**Pacific Gas and
Electric Company®**

PG&E Letter DCL-12-017

Docket No. 50-275, OL-DPR-80
Docket No. 50-323, OL-DPR-82
Diablo Canyon Units 1 and 2
Response to NRC Request for Additional Information regarding PG&E Letter
DCL-11-059, "License Amendment Request 11-04, Revision to Technical
Specification (TS) 3.6.6, 'Containment Spray and Cooling Systems,' TS 3.7.5,
'Auxiliary Feedwater (AFW) System,' TS 3.8.1, 'AC Sources - Operating,' TS 3.8.9,
'Distribution Systems - Operating,' and TS Example 1.3-3"

PG&E Response to NRC Request for Additional Information regarding PG&E Letter DCL-11-059, "License Amendment Request 11-04, Revision to Technical Specification (TS) 3.6.6, 'Containment Spray and Cooling Systems,' TS 3.7.5, 'Auxiliary Feedwater (AFW) System,' TS 3.8.1, 'AC Sources - Operating,' TS 3.8.9, 'Distribution Systems - Operating,' and TS Example 1.3-3."

FSAR UPDATE
UNITS 1 AND 2 DIABLO CANYON SITE
FIGURE 15.4.2-13 MAIN FEEDLINE RUPTURE WITH OFFSITE POWER AVAILABLE STEAM GENERATOR PRESSURE AND TOTAL MASS TRANSIENTS

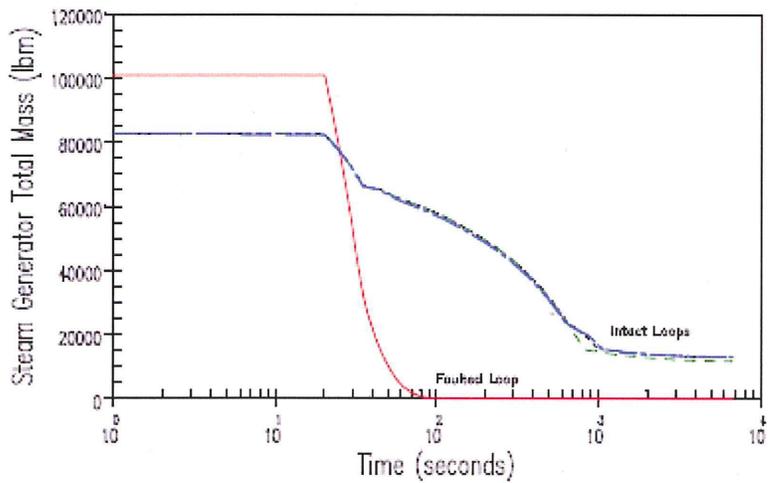
The feedline rupture accident does result in a faulted and depressurized SG. Therefore, PG&E performed additional evaluations of the AFW system performance to demonstrate acceptable accident mitigation with one LCV on each MDAFW pump incapable of automatically throttling for runout protection as designed. In TS 3.7.5 Condition B, each MDAFW pump would still have one LCV capable of automatic throttling. The limiting plant condition that occurs during a feedline rupture occurs when the faulted SG is completely depressurized. However, the feedline rupture initiates a rapid main steam isolation signal that automatically isolates the intact SGs from the fault. As shown in FSARU Figure 15.4.2-13, the intact SGs then pressurize to the lowest main steam safety valve setpoint to provide secondary steam heat removal well before the faulted SG is completely depressurized. PG&E has performed evaluations of the AFW system performance to establish that the single operable LCV on each MDAFW pump is still capable of preventing adverse pump runout conditions for the limiting single failures assumed in the FSAR accident analyses.

Table 1 provides a summary of the AFW system single failure evaluation for a feedline rupture accident while in the specific plant configuration allowed by the TS 3.7.5, Condition B. The Base Case shows the normal AFW system performance with no failures while the other three cases show the performance for the limiting three active system failures evaluated. The evaluation is performed for a feedline rupture accident that has occurred on SG 3, which has the most limiting system hydraulic resistance. The FSARU feedline rupture analysis conservatively does not credit any AFW flow for the first ten minutes, until after the operators have manually isolated the faulted SG. Therefore, the values provided in Table 1 represent the AFW flow that would be available to the intact SGs for each single failure case after the faulted SG is isolated. Table 1 demonstrates that the limiting Case 1 failure of the TDAFW pump still ensures one MDAFW pump provides the minimum 390 gpm flow to two intact SGs. These evaluation cases maintain additional conservative margin since no credit is taken for any MDAFW 3 pump flow to SG 4, which could be provided in Cases 1 and 2 after the faulted SG 3 is isolated.

In summary, the configuration in TS 3.7.5 Condition B is capable of automatically fulfilling the required AFW system design basis accident mitigation functions when considering a limiting single active system failure.
